FASHION.COM LIMITED

Buildings Information

Observations

F 2 type Foundation section details

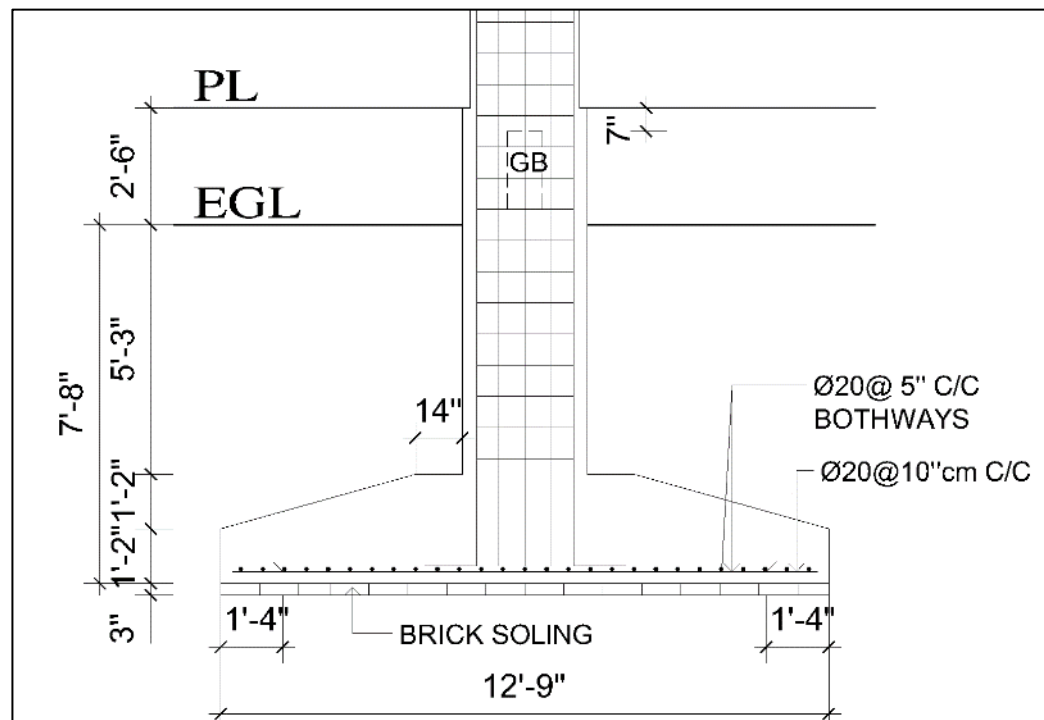
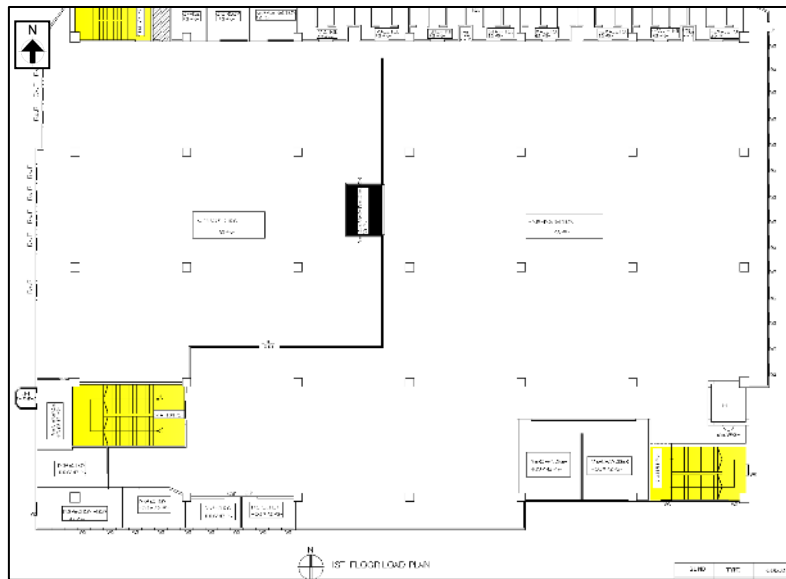
**Punching stress of foundation exceeds normal
design limit**

Cursory calculation indicates that, the punching capacity of the F2 foundation exceed normal design limit considering 3 kPa live load and provided material & soil test reports. Building Engineer to review design, loads and foundation stresses in compliance with section 1.9.1.2 of BNBC.

Load plan of 2nd , 3rd and 4th floor 2 kPa

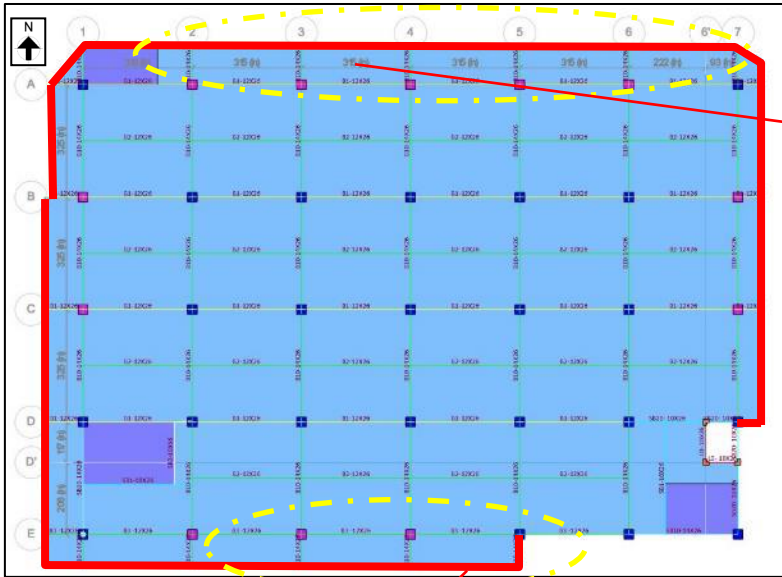
The construction of the building was completed on 2017 but the load plan and design was developed considering 2 kPa for 2nd, 3rd and 4th floor and 3 kPa for 1st floor. Building engineer is required to revise the DEA report considering minimum floor live load (3kPa) as per BNBC (2006) load combination.

Edge beam on Toilet area

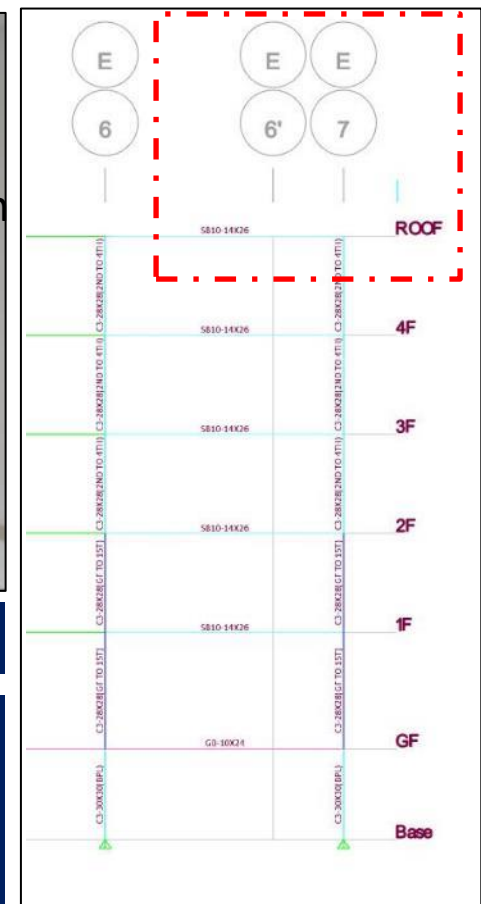
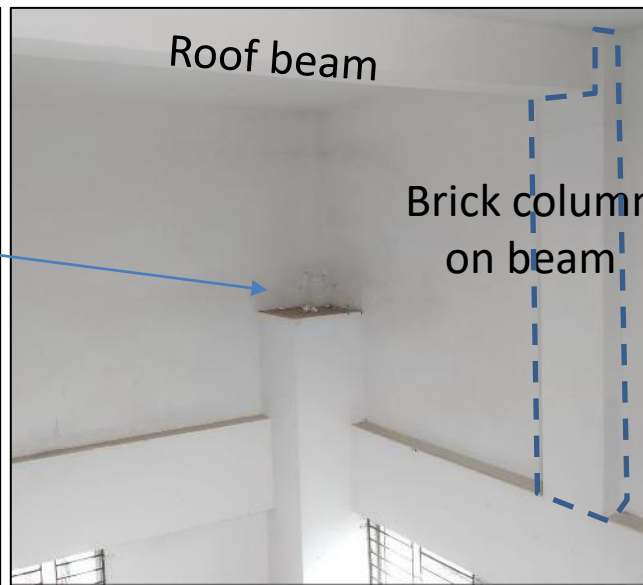
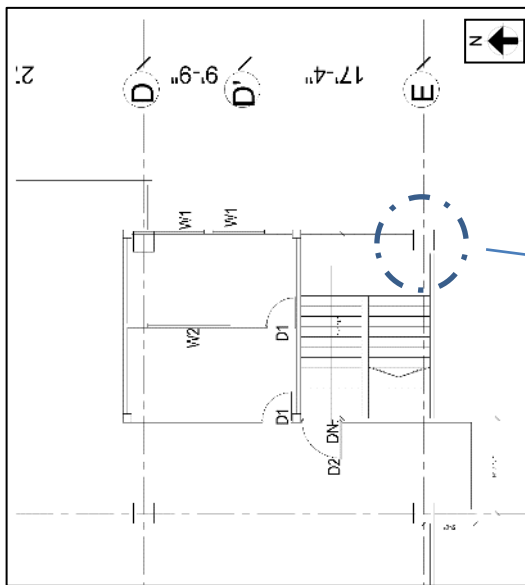
Edge beam (highlighted in red)not assigned on the FEA model

The edge beam was observed on the cantilever area as per the beam layout. This beam has not been addressed in both drawing or FEA model. But on the site, a continuous beam on the periphery was observed. The measured beam depth was 510 mm at ground floor. The drawing need to be revised along with DEA report.

Column C3 (Grid E07) location on drawing and in site

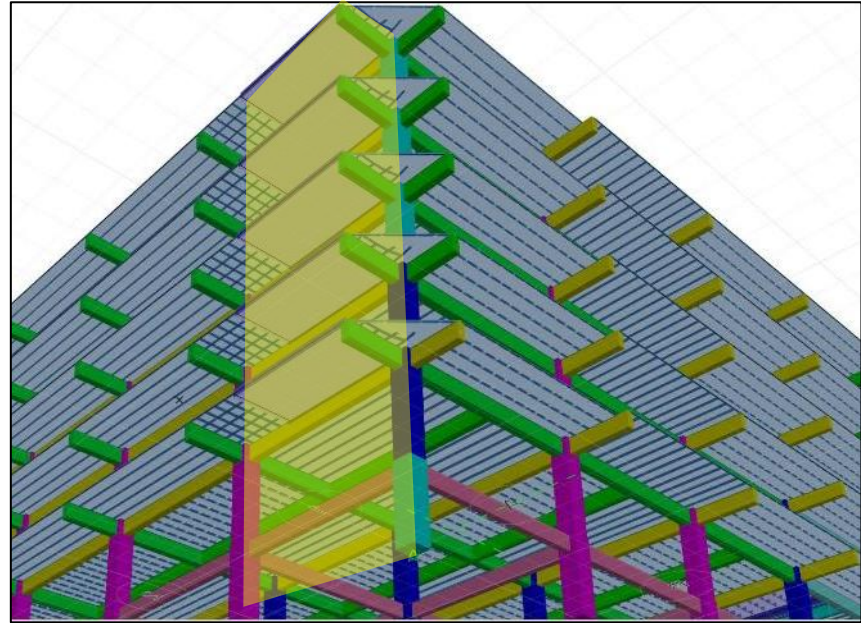
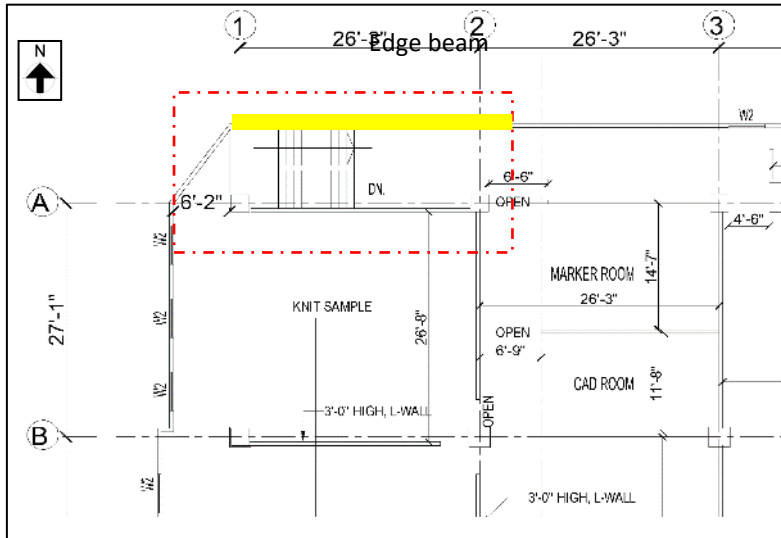
As per architectural drawing, there are a garret on the east and west stair case. On the east stair case, the column does not reach up to the roof level. On the FEA model non of this garret area has been assigned. The roof slab and roof beam is seems to be supported by the masonry wall around. This system may rise the issue of lateral instability of the roof. Building engineer is required to address this issue and revise the DEA report along with the drawing.

Column C3 on FEA model, no section defined on the garret

Stair on north west direction

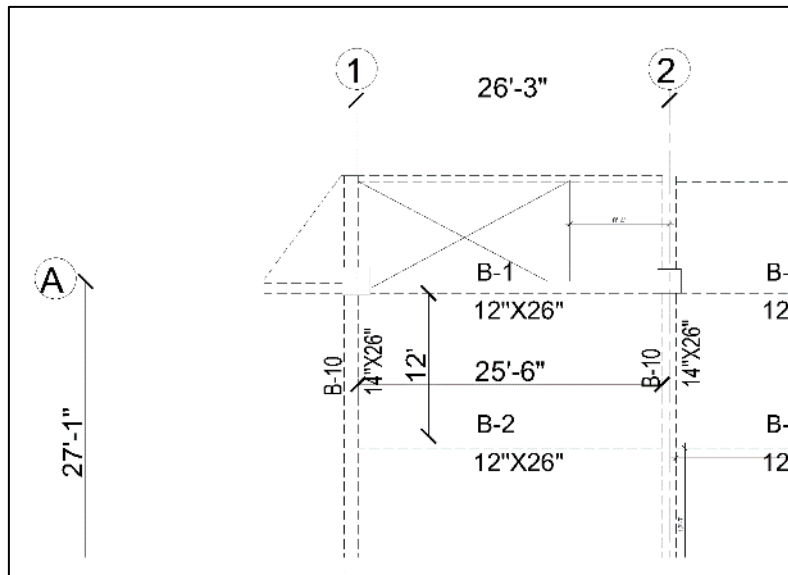
The highlighted area is the assigned stair on FEA model

The stair is fully resting on the beam and two columns on the west. There is an edge beam to support on the north side of the stair. There is no beam on the transverse direction either, to support the landing slab. Thus, the load path of the stair is not clear. Building engineer is to check the overall stability of the stair along with the DEA report.

Crack on roof beam near the support

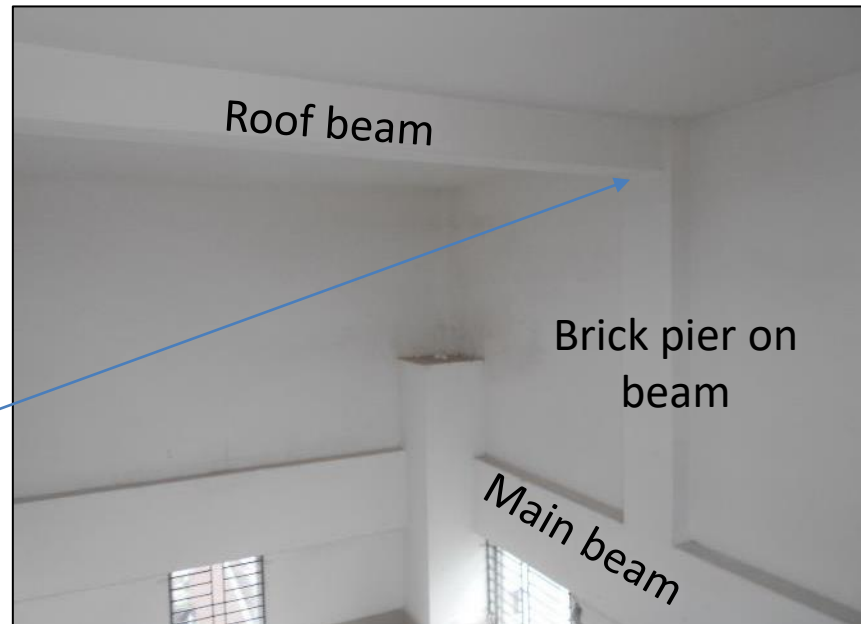
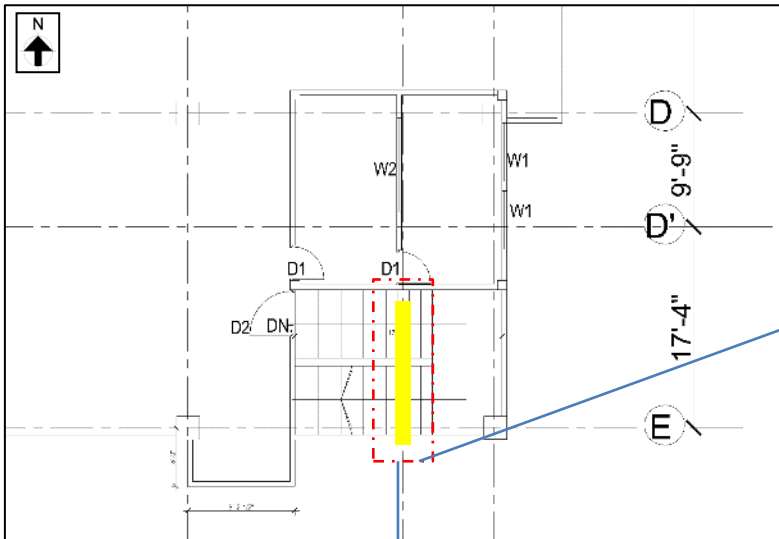
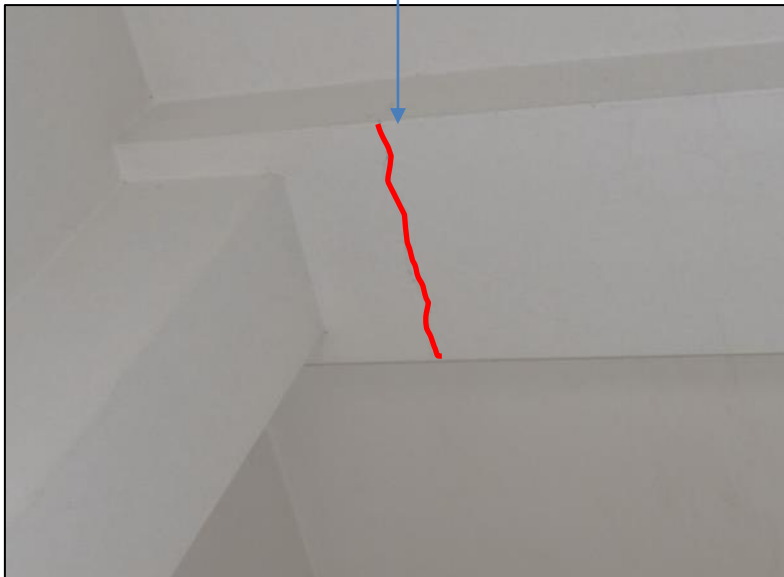
Roof beam is resting on brick pier which is resting on edge beam

Crack was observed near the support of the roof beam. The lateral stability of this roof beam along with the slab is unknown, as the beam-slab is resting on the periphery wall. Building engineer is required to investigate the crack as per part of DEA and suggest any remediation required.

Roof layout (rubbish stacked area)

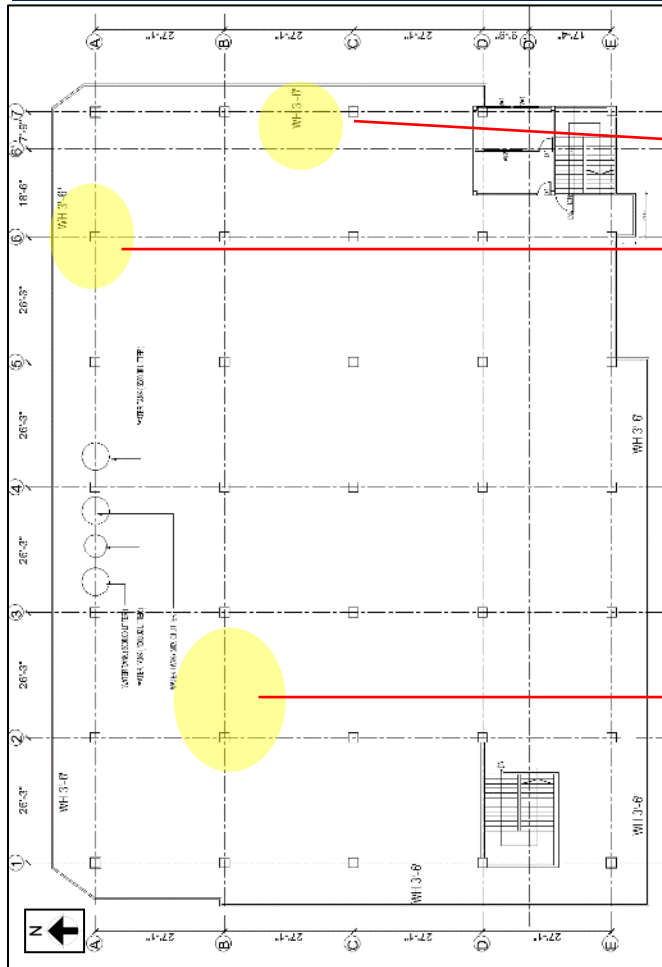
Rubbish was found on the different location of the roof slab. This stacking may deteriorate the structural integrity of the concrete of the slab by absorbing water in certain places. The drainage pipes were found on north and west direction only. Water stagnant was found on the north side. Building engineer is required to remove the rubbish materials from roof and develop proper drainage system.

Floor plan

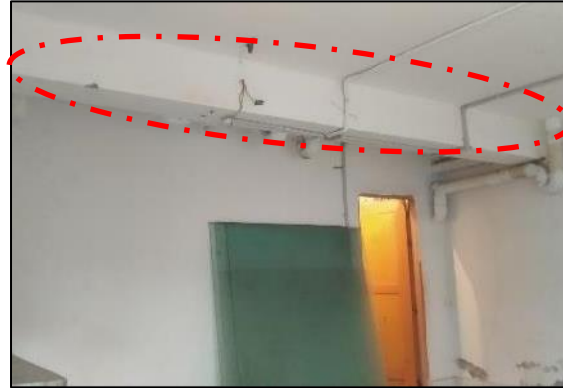
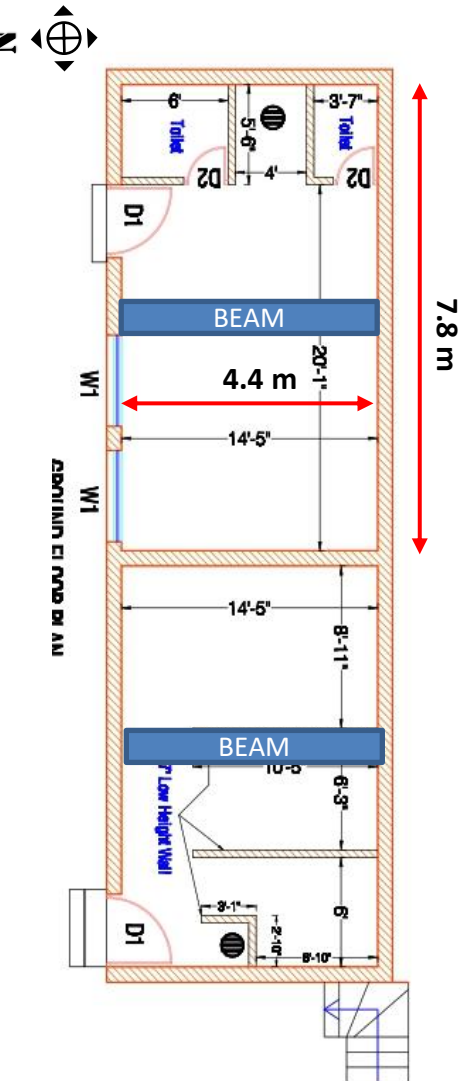
Beam on mid span

The architectural drawing was available during inspection. The structural system of jhute building is, RC Beam slab supported on load bearing masonry wall which is resting on the concrete walls of underground water reservoir (UGWT). There are two beams found on the mid span of this building on both ground floor and 1st floor. There was no structural drawing to confirm the dimension and rebar of these beams, opening of the masonry load bearing walls and UGWT. Drawing to confirm the foundation system is also unavailable. There is a plastic water tank on the roof. No drawing found for the steel stair either. Building engineer is required to produce as-built documents and check overall stability against vertical and lateral loads as part of DEA.

Steel stair

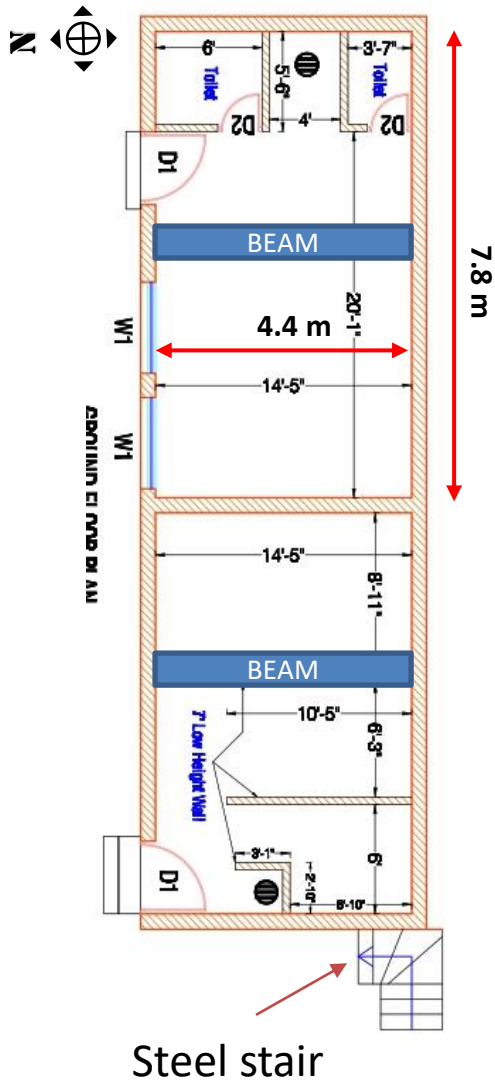
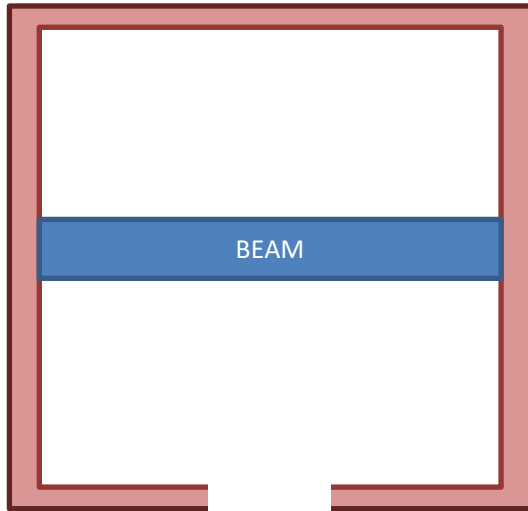
The stair on the west side is also poorly connected with the building wall with one side. Non engineering connection for the steel stair was found.

Roof plan

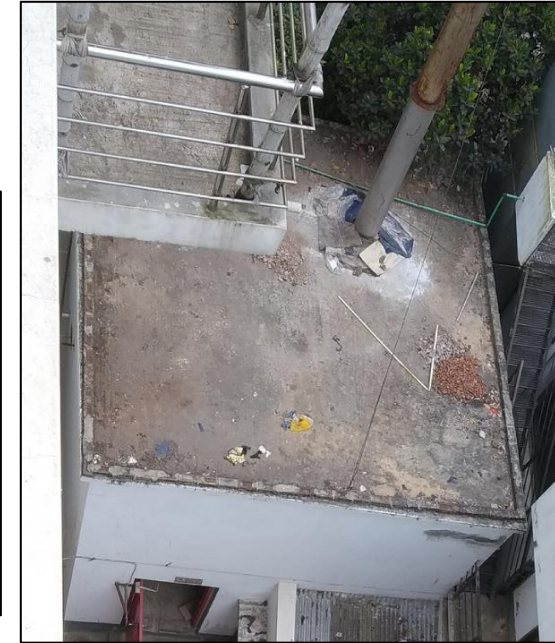
There were no credible as-built structural drawing or documents to review. This masonry structure with 5.36 height is totally resting on 250 mm brick wall. The Factory engineer is required to survey the structures and prepare as-built drawings.
